**Susitna-Watana Hydroelectric Project
(FERC No. 14241)**

**Terrestrial Furbearer Abundance and Habitat Use
Study Plan Section 10.10**

**Initial Study Report
Part B: Supplemental Information (and Errata) to
Part A (February 3, 2014 Draft Initial Study Report)**

June 2014

Figure 4.1-1. Location of Ground-based Transects, Occupancy Survey Cells, and Hair-snag Sites Sampled in Winter 2013.

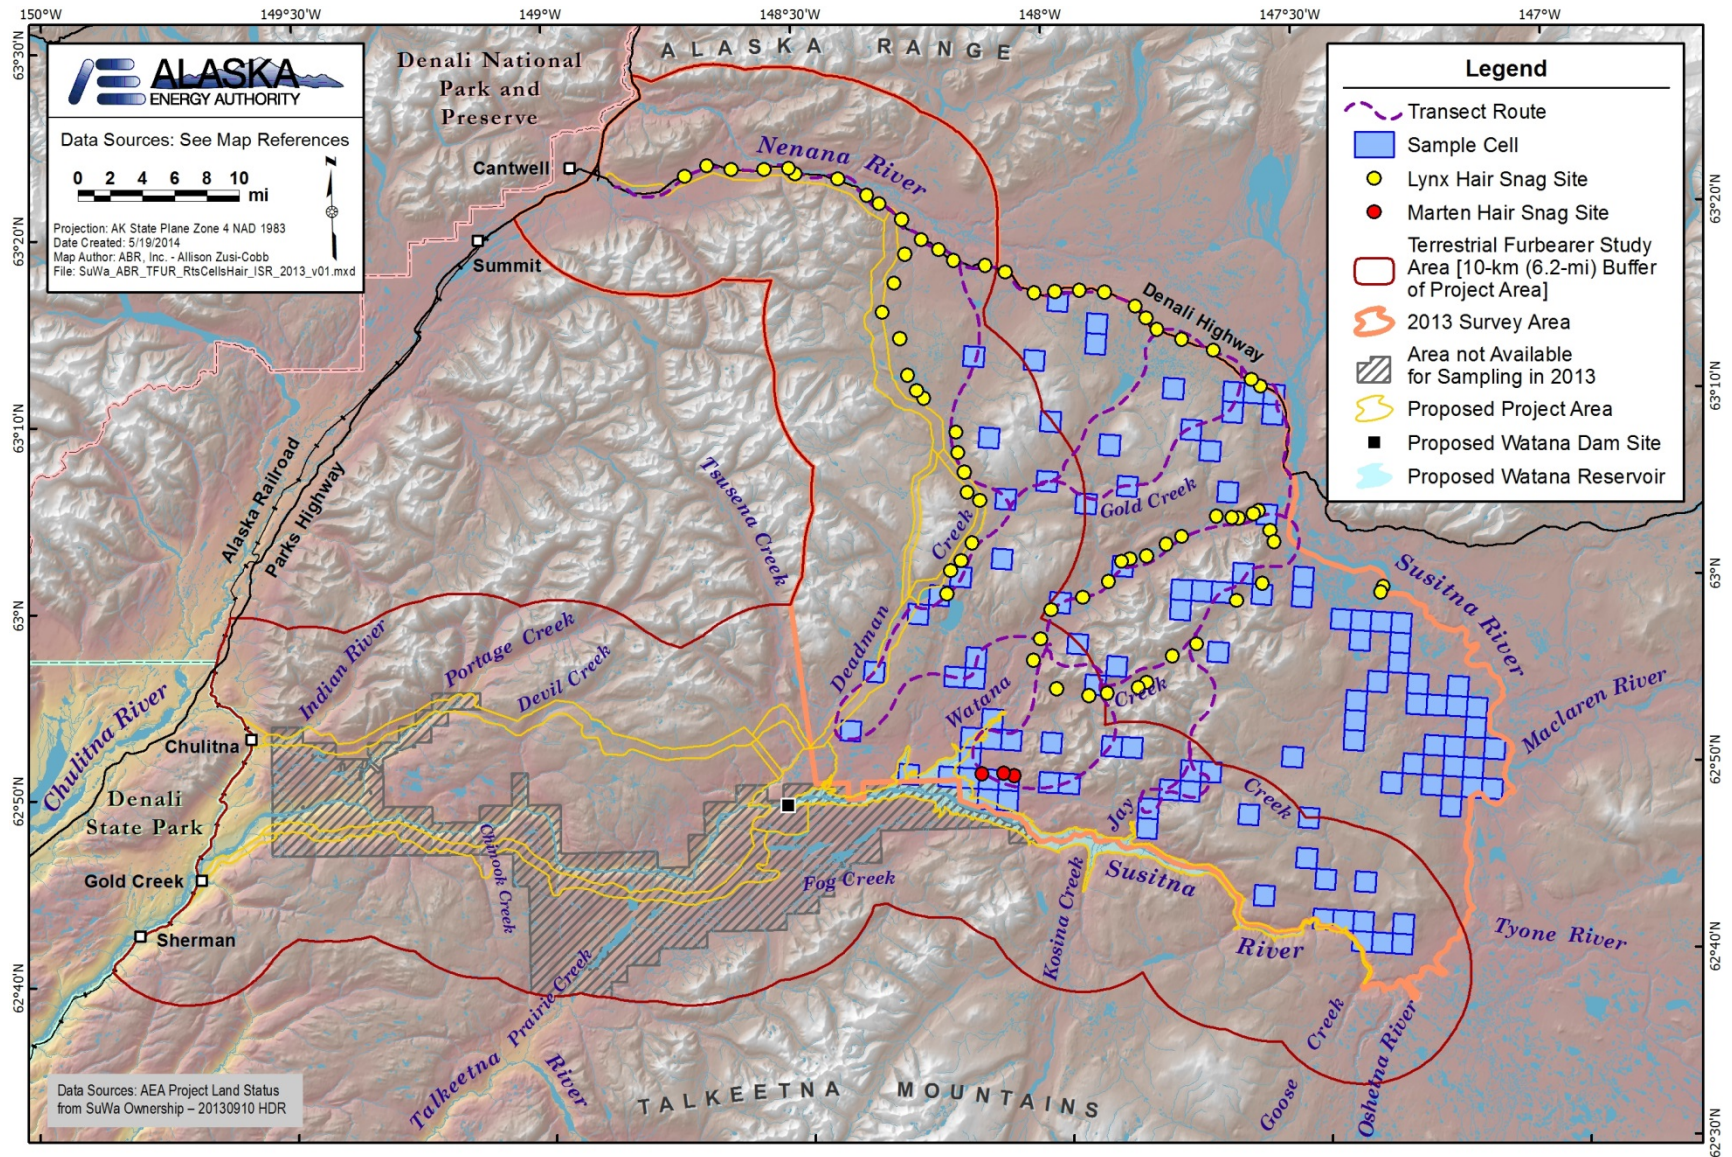
ISR Study 10.10, Part A, Fig. 4.1-1, Page 14	In response to a request from David Tessler (ADF&G Division of Wildlife Conservation) for supplemental information in the wildlife technical meeting on March 6, 2014 (see http://www.susitna-watanahydro.org/wp-content/uploads/2014/03/2014-03-06TT_Wildlife_MeetingNotes.pdf), the locations of hair-snag sites for lynx and marten in winter 2013 have been added to Figure 4.1-1. The revised figure follows this table.
--	---
